PROJECT NAME: 78 Clifton Road (Our Lady of Perpetual Help) Church Alterations

PROJECT NO.: 14214.002.M.001

DATE: 2016-07-21

POST ADDENDUM NO.: M-01

4 CONTROL VALVES (REVISED) (MSD-7051)

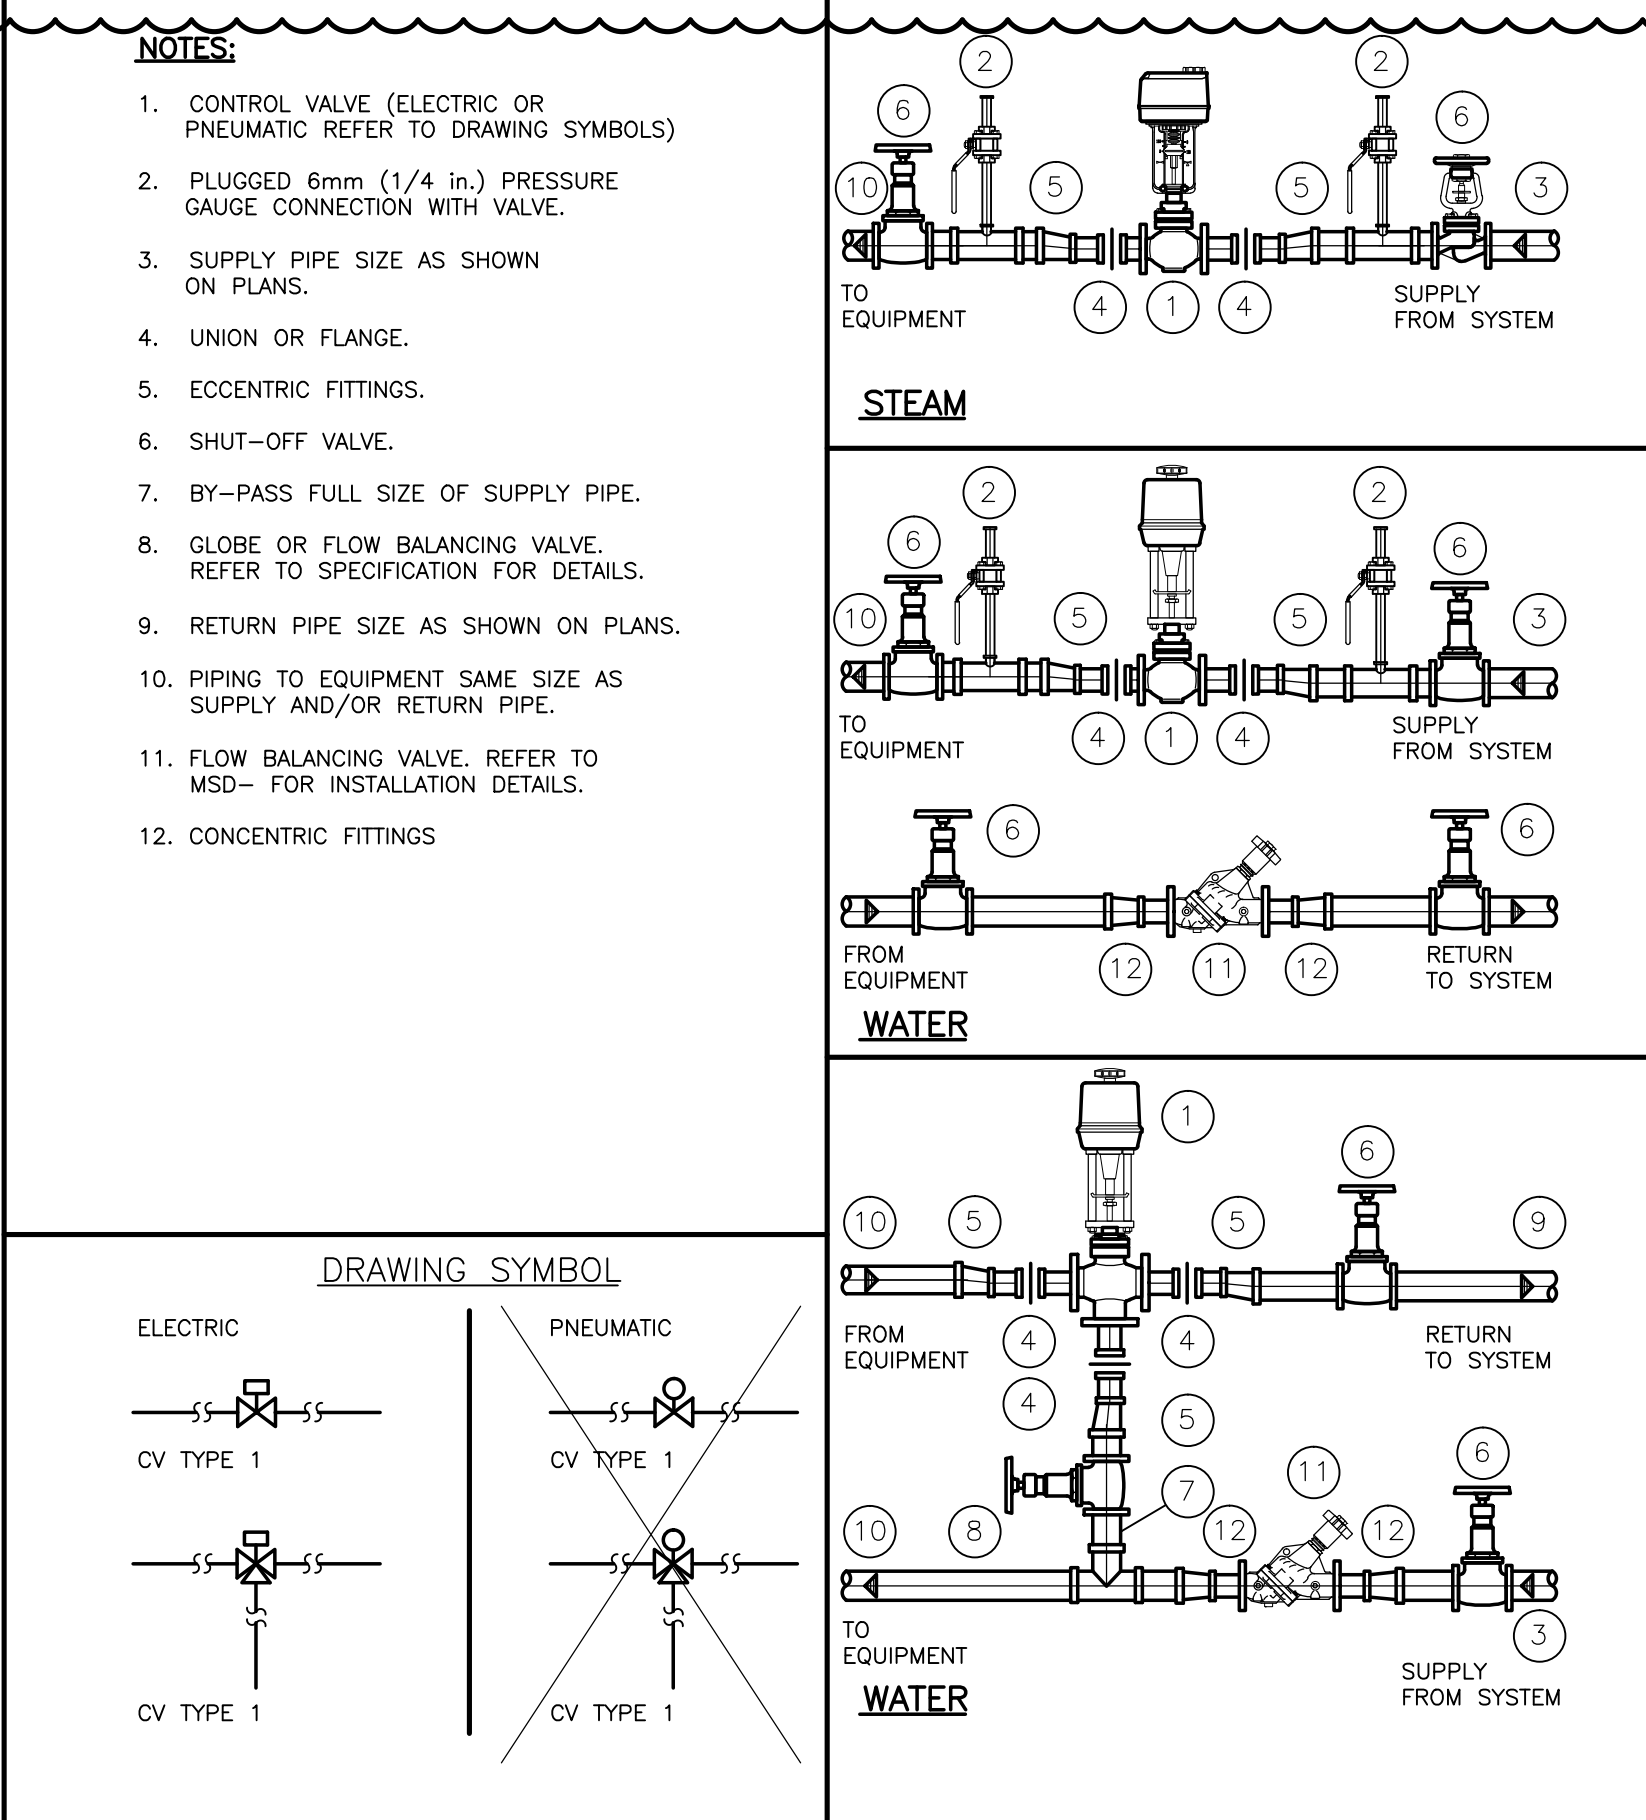
- 4.1.1. Replace entire drawing package with that attached. Changes identified with revision clouds.
